Memorandum –Response to Parks

To: [REDACTED] – Barker & Associates
From: Terra Studio
Re: A Memorandum Responding to the Park Pre-App meeting

This memorandum responds to items outlined in Barker and Associates meeting minutes, dated 19 November 2025, relating to the design and compliance of the two proposed parks in Delmore.

Figure 3 – Stage 2 park amended slightly since the initial application to suit the new collector road width and roundabout.

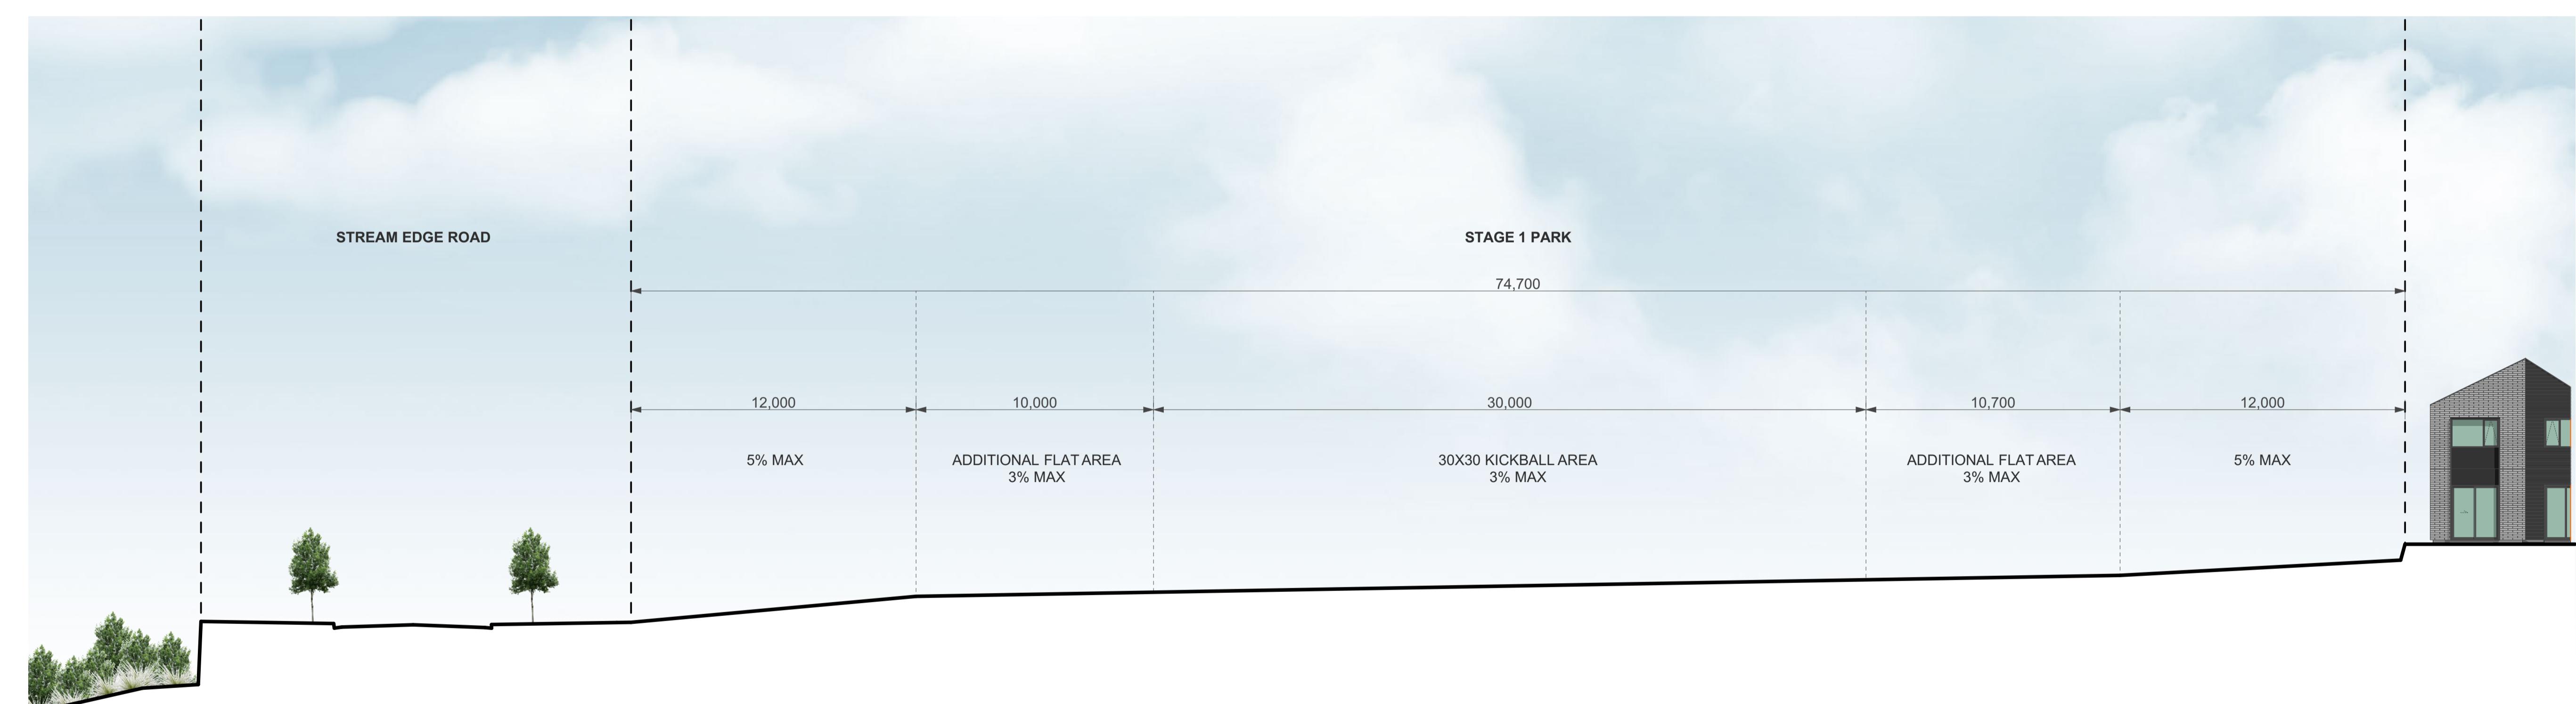
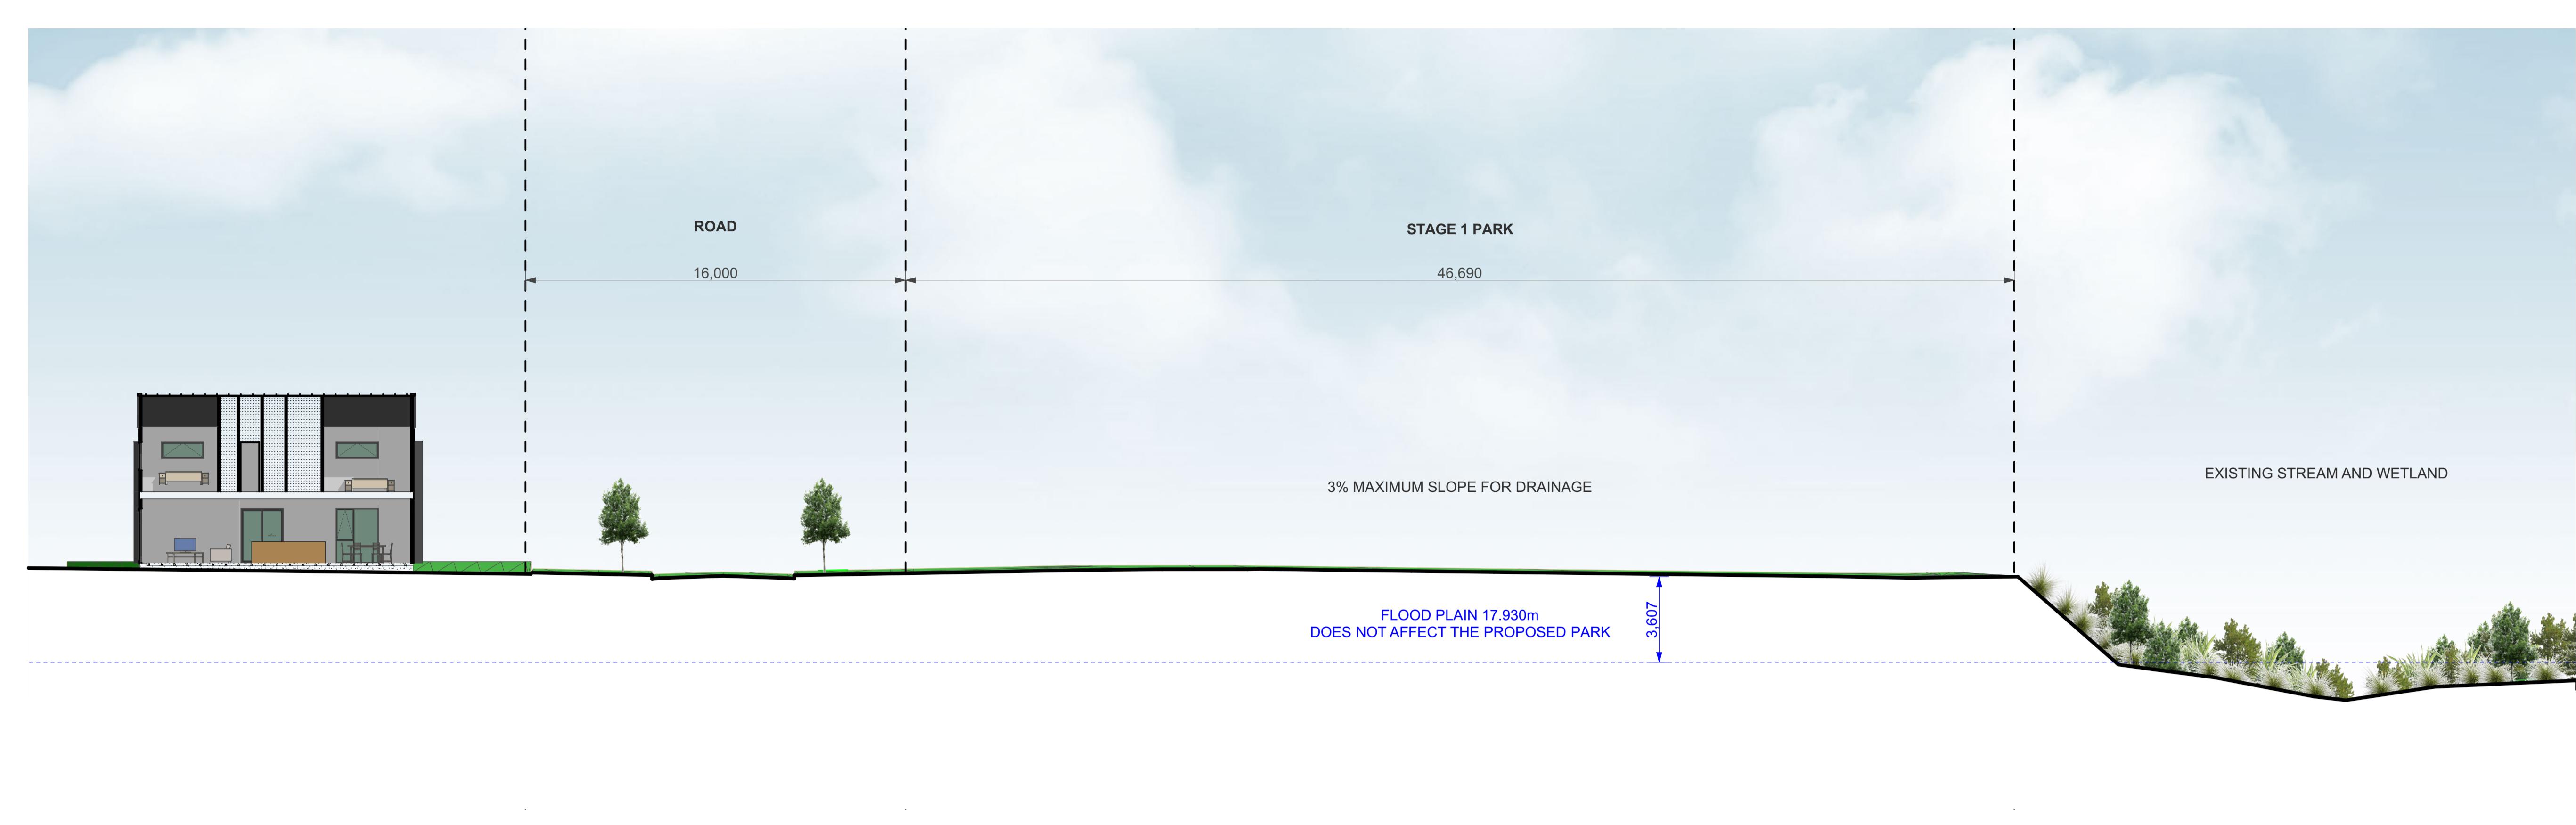
At the pre-app meeting on 19 November 2025, the potential use of a 1m high retaining wall around the park perimeter was discussed to increase the area of land with a 3% gradient. Following detailed design investigations, the applicant determined that a wall in this location would require substantial structural engineering due to surcharge from the houses and 1:3 slopes above, as well as the instability from the 1:3 batter slope below. Although the wall would appear to be only 1m high, its rake, structural thickness, and required embedment depth would outweigh the potential benefits.

The location and boundaries of the Stage 2 park were slightly amended to suit the new collector road and roundabout that were introduced for the second Delmore lodgment, however the fundamental design and levels remain largely unchanged. The northern boundary of the park now interfaces the proposed commercial area, with pedestrian access between the two requiring some stairs.

Figure 3 below highlights the park design which has been amended from the initial application and its interface with the commercial area.
